工程指示 / 要求簡箋(E.I.)

工程指示編號：EI / 3580 / 21

工程名稱：亞皆老街中電

工程項目：後裝窗 地盤用玻璃 B.M. (T1-T3: 1-21/F) (90 件) 玻璃 放行

美特鋁質 有限公司 MIDI Aluminium Fabricator Ltd.	類別	物料號			
	制圖	Ivan	2020-09-04	圖號	GL01-04~05, 11
修改		復核		數量	—
日期		批准		位置	后裝鋁窗及鋁門用

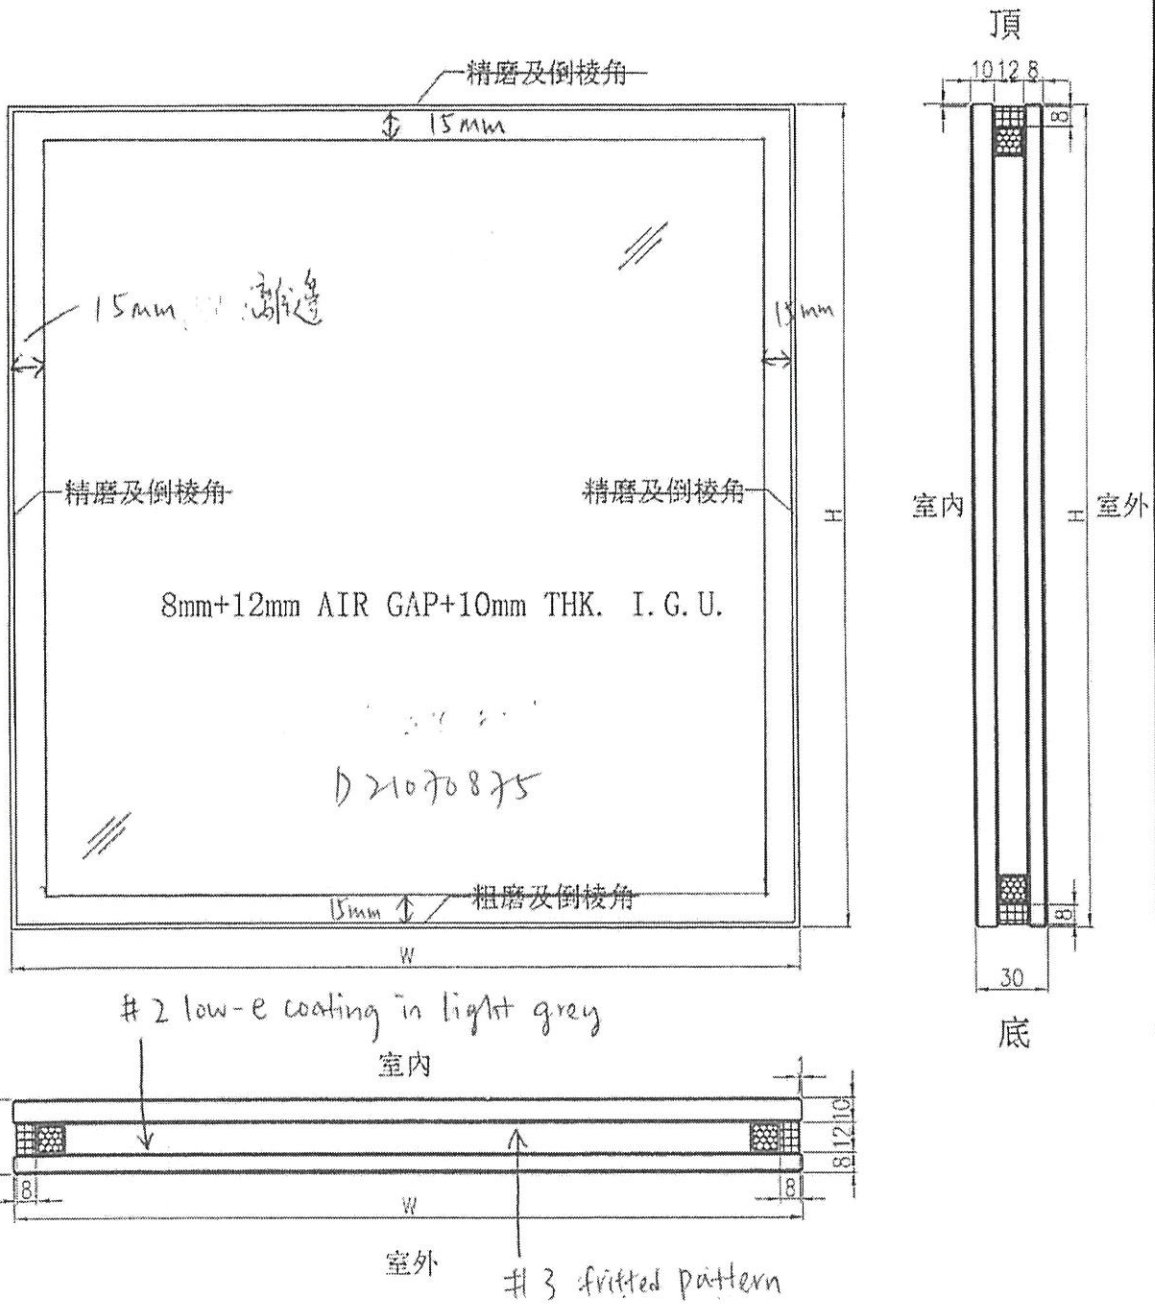
B 版：顧問已批核 fritted pattern 玻璃。現放行生產所有玻璃 (共 90 件)。

因則師要求部分後裝窗改為磨砂玻璃 (原 EI3182)，請按 B.M. 訂購 T1-T3: 1-21/F 磨砂玻璃 (共 90 件) (T1/T3: 各 36 件。T2: 18 件) 直送地盤。 T3 優先生產。 分判包箱。

IGU 膠用 DC983 結構膠 玻璃要熱浸 Low-E: SEE0-83T
